# Brandix Apparel Bangladesh Ltd.

Plot 39-43, 46-49, EPZ Cumilla  
(23.446381, 91.188181)

03 August 2022

# Observations

Storage rack found within the building without braced/anchored

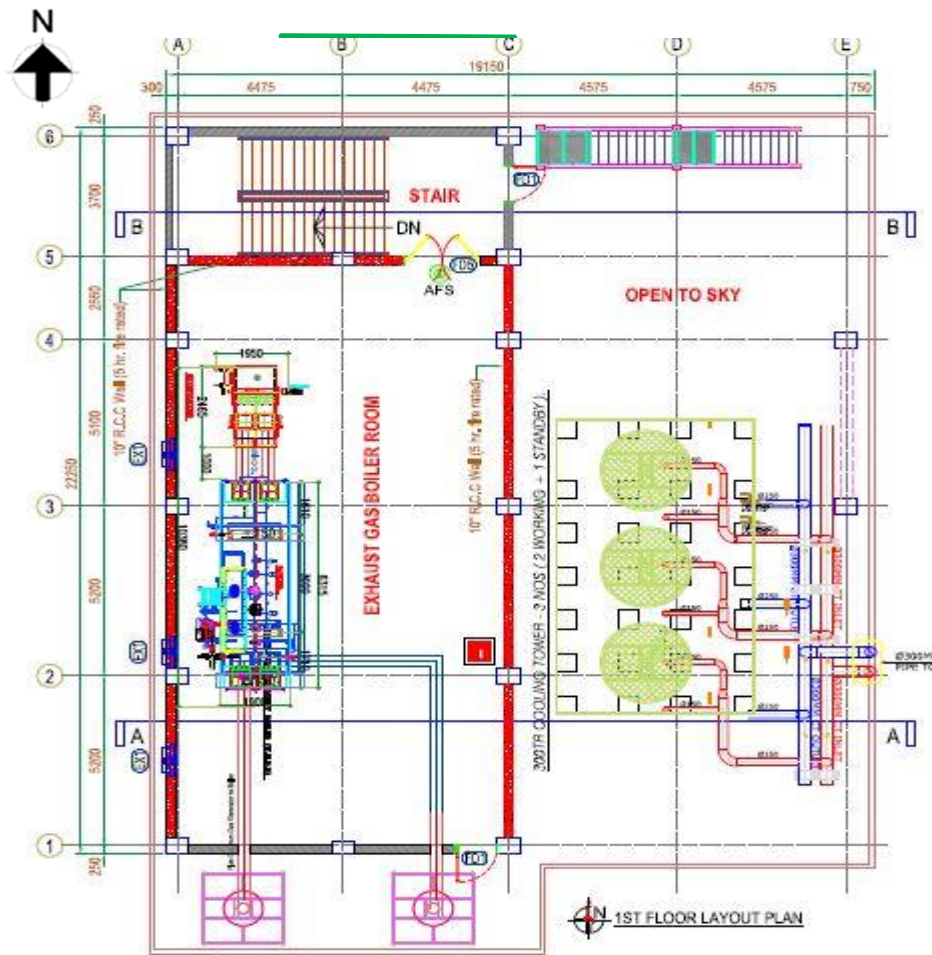
Building engineer is required to brace/anchor all non structural elements.

| Item No. | Observation                                                                           | Recommended Action Plan                                                                                         | Recommended Timeline |
|----------|---------------------------------------------------------------------------------------|-----------------------------------------------------------------------------------------------------------------|----------------------|
| 06       | Non-structural elements found unbraced/not anchored (Building 1: Production Building) | Building engineer is required to brace/anchor all non-structural elements.                                      | 6-weeks              |

Steam flow adjacent to periphery beam

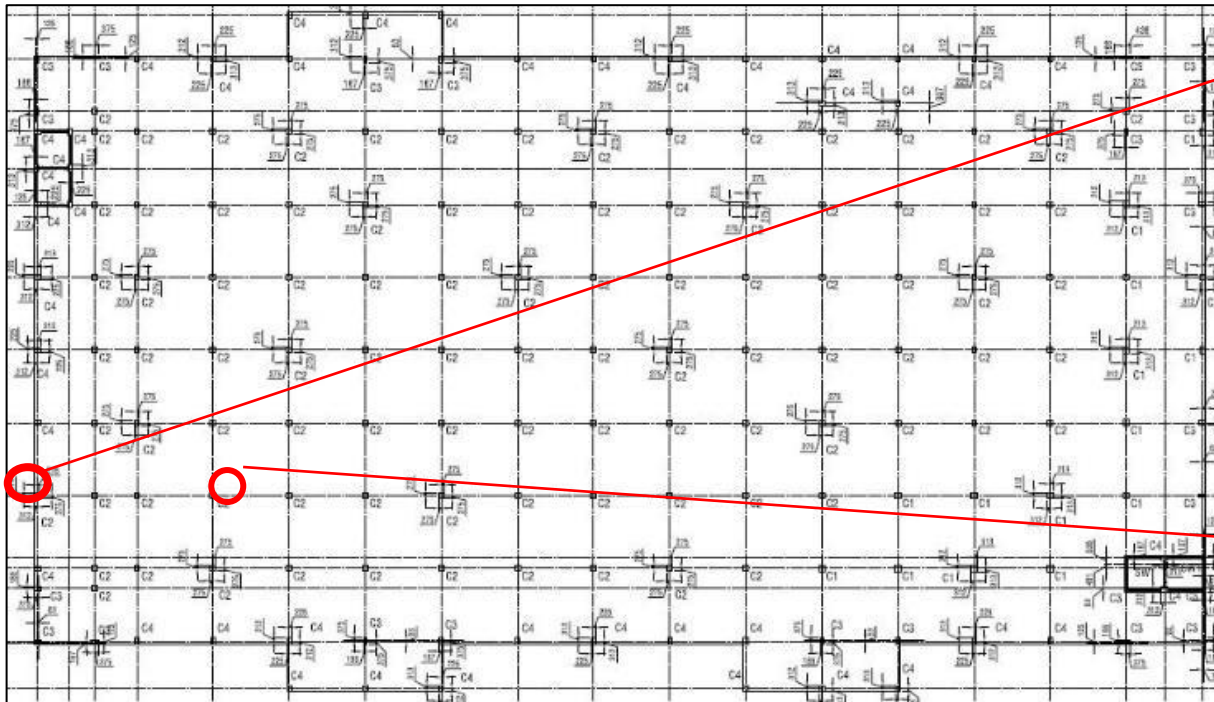
Steam flow from boiler was observed adjacent to periphery beam which may damage the beam in the long run. Building engineer is required to divert the steam flow to another direction to avoid the future damage of beam.

| Item No. | Observation                                                                           | Recommended Action Plan                                                                                         | Recommended Timeline |
|----------|---------------------------------------------------------------------------------------|-----------------------------------------------------------------------------------------------------------------|----------------------|
| 10       | Steam flow near structural element (Building-3 : Utility Building)                    | Building engineer is required to divert the steam flow to another direction to avoid the future damage of beam. | 6-weeks              |
